From: [REDACTED]
Sent: 2025-09-04 星期四 12:12:59
To: [REDACTED]
Cc: [REDACTED]
Subject: Re: Planning Application No. A/YL-PH/1069 - Departmental Comments
Attachment: LD-L741-SD01(R7).pdf

Stormwater Drainage Design

Proposed Temporary Private Vehicle Part Associated and Filling of Land
for a Period of 3 Years of Land Lot 741 (Part) in D.D. 111 in “Village
Type Development” Zone, Pat Heung, Yuen Long, N.T.

Responses to Comments for Drainage Services Department
Planning Application No. TPB/A/YL-PH/1069

Plan of Catchment Areas

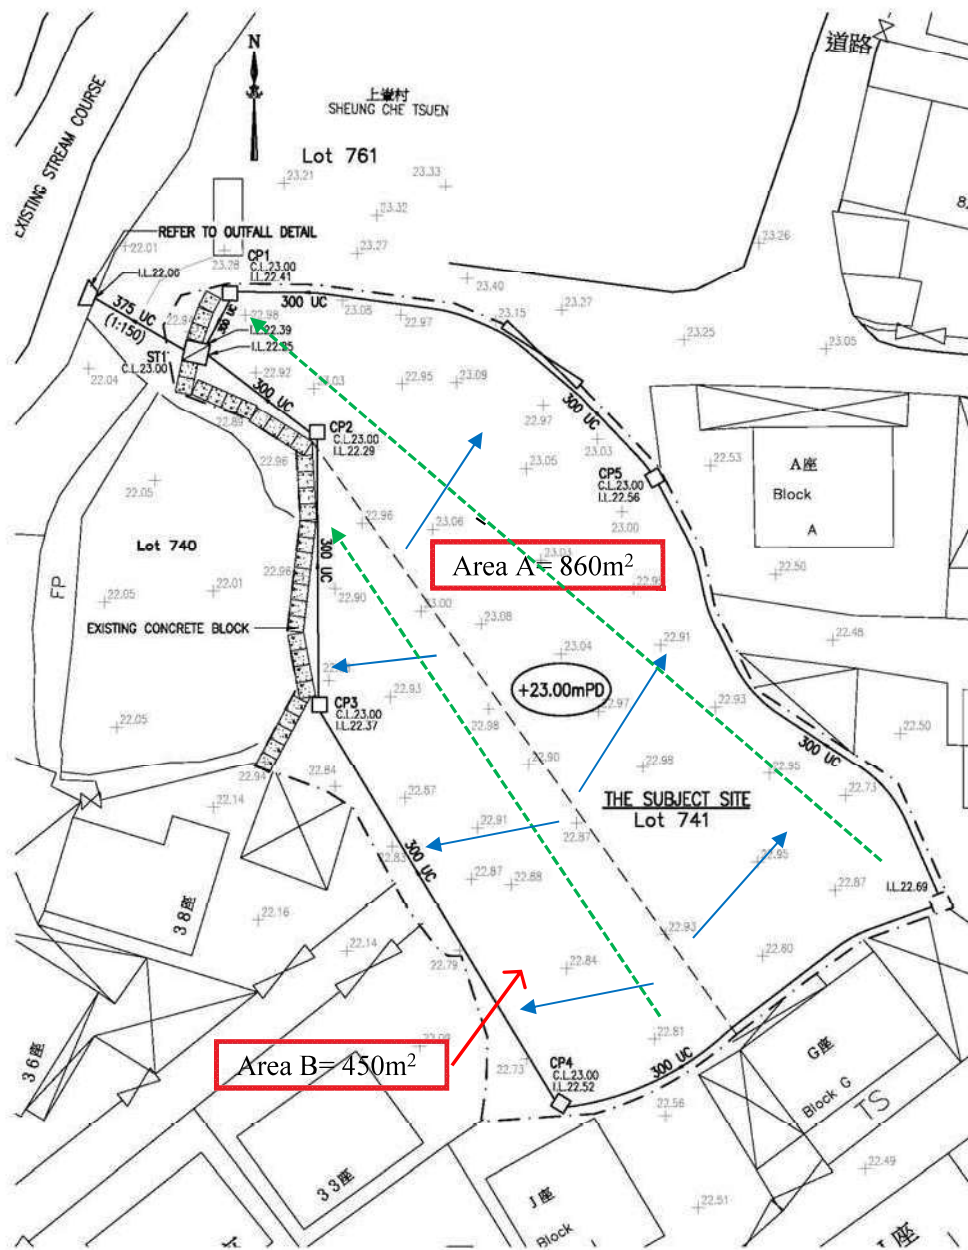
| (b) 300 UC with gradient of 1:200 are proposed by the applicant. Please demonstrate with hydraulic calculation that the proposed drainage facilities are adequate to collect, convey and discharge the surface runoff accrued on the application site and to the overland flow intercepted from the adjacent lands. Please also indicate the gradient of the proposed 375 UC and showing its C.L. and I.L. at outfall detail. | See attachment |

The catchment area for the design of surface channels is shown below :

Therefore, used 375mm UC is adequate for catchment area of the application site.
